**ITEM 1**

**TWO 3 STOREY BLOCKS OF 18 ONE BEDROOM SHELTERED HOUSING FLATS (USE CLASS C2) AND ASSOCIATED COMMUNAL AREAS, PLUS CAR PARKING, PEDESTRIAN AND CYCLE ACCESS AND LANDSCAPED GARDEN AREAS AT FORMER SITE OF AVENUE VILLA, AVENUE ROAD, WHITTINGTON MOOR, CHESTERFIELD, DERBYSHIRE, S41 8TA FOR DIGNUS HEALTHCARE**

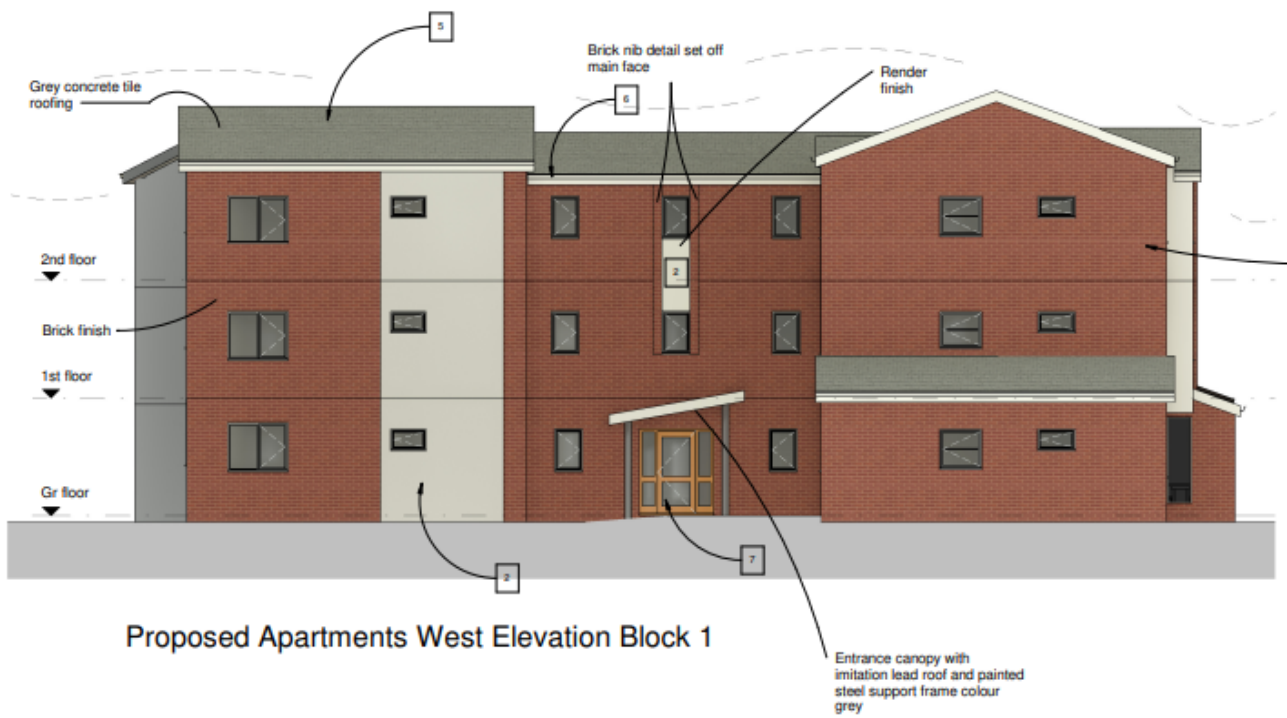
- 5.6.6 The inwards facing blocks would enclose a central courtyard completely dominated by car parking, which provides a poor quality environment for future occupants and does not create a sense of place within the development, nor contribute positively to the locality.

- 5.7.9 The proposed central space between the two blocks of accommodation is entirely dominated by the car parking provision which is considered to be an unacceptable design solution which would result in the lost opportunity to provide a high-quality shared garden area that connects the two blocks of accommodation. This is considered to provide a poor quality environment for future occupiers that will have a detrimental impact on their amenity.

- 5.8.5 The siting of the proposed parking court within the centre of the site is considered to dominate the scheme and reduce the level of potential outdoor amenity space for the residents. In addition, no justification is provided for the reduction in parking spaces from 17 spaces in the outline application, to 11 spaces in this application, despite the residential capacity being doubled from 9 residential units to 18. Whilst the Borough Council does not have minimum parking standards either within Local Plan policy or guidance within the Successful Places SPD, there is an expectation that parking provision should be appropriate taking into account the size, type, mix and use of the proposed development, the proximity of the site to local employment opportunities and public transport provision, the likelihood of on-street parking issues arising and local car ownership levels.

- 5.8.7 Furthermore, the proposed layout of the car parking is likely to cause issues in terms of vehicular movements, particularly in spaces 01, 08, 09 and 10 where it would be difficult for vehicles to manoeuvre into and out of these spaces if the surrounding spaces were occupied. Vehicle tracking hasn't been provided within the parking areas which does not provide sufficient confidence that parking spaces would function appropriately without raising safety concerns relating to the pedestrian entrance to Block 1 immediately adjacent to the parking area.

- 5.8.9 The proposed site plan shows a refuse collection area and bin storage area to the front of the site adjacent to the Avenue Road frontage. A further bin storage area is shown to the south of the site which is presumed to service Block 2. The southern bin storage area is some 63m away from the refuse collection area to the site frontage, the Successful Places SPD and British Standard 5906:2005 recommend a maximum carrying distance for refuse collectors of 15m. No information has been provided which details anticipated collection methods or responsibility for the transport of refuse from the southern bin storage area to the site frontage.

- 5.8.10 The proposed site layout shows the provision of a fire vehicle tracking route entering the site and travelling through the car park into the adjacent site via a gated access. The development approved under CHE/21/00926/FUL requires secure gated access in order to protect the safety of future occupants of the approved care home. No information has been provided which details the operation of the shared gate between the two sites and how this would function in the event of an emergency whilst maintaining the safety and security of residents.

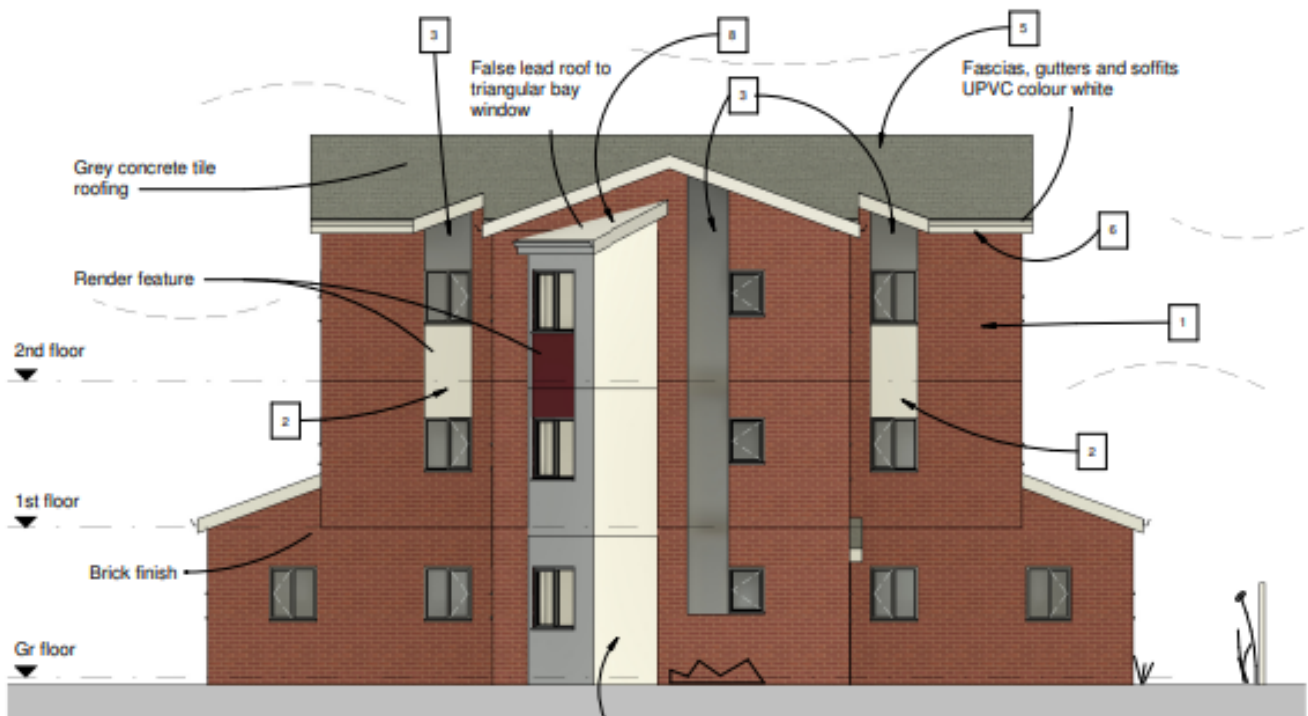
- 4.5 Block 1 will have a narrow frontage to the Avenue Road (north) elevation (approx. 6.9m) with a triangular oriel window bay facing the street, with a false lead roof which sits below the ridge of the projecting gable that will form the principal elevation fronting Avenue Road. The gable ridge sits at approx. 10.10m and intersects with a cross gable to the rear of the block which widens the building to approx. 17.7m. The widest point of the building will feature two “lean to” style hips to the ground floor to provide additional ground floor accommodation and will be approx. 13.4m at first floor level and above. The cross gable ridge height sits at approx. 10.55m with an eaves height of approx. 8.6m. The building will be approx. 26.8m deep in total.

- 4.6 To the rear, the proposed elevations show a rear entrance way in which sits below a rear-facing gable which has been “split” which reflects, to a degree, the front-facing elevation of the approved care home on the adjacent site (CHE/21/00926/FUL). To the western elevation an entrance way is shown which provides an entrance for pedestrians using the side access route.

- 5.6.5 The two blocks of accommodation face inwards to a central courtyard rather than providing a main entrance to the development along Avenue Road. This provides a poor relationship to the street scene with no active frontage which would be harmful to the vitality of the wider street by not creating a positive relationship between public and private realm. The pattern of development along Avenue Road is terraced or close-knit semi-detached dwellings with small front gardens and buildings relatively close to the highway edge. The proposed form of block 1 towards the site frontage would represent an incongruous addition to the street scene which does not reflect the grain of development.

uses by virtue of its scale. The proposed 3 storey block would be out of character within this part of the site and would be over dominant with respect to the residential properties to the south. Existing vegetation which would have provided a degree of screening has been removed. This is considered to be harmful to the character, form and setting of the site and represent inappropriate development.
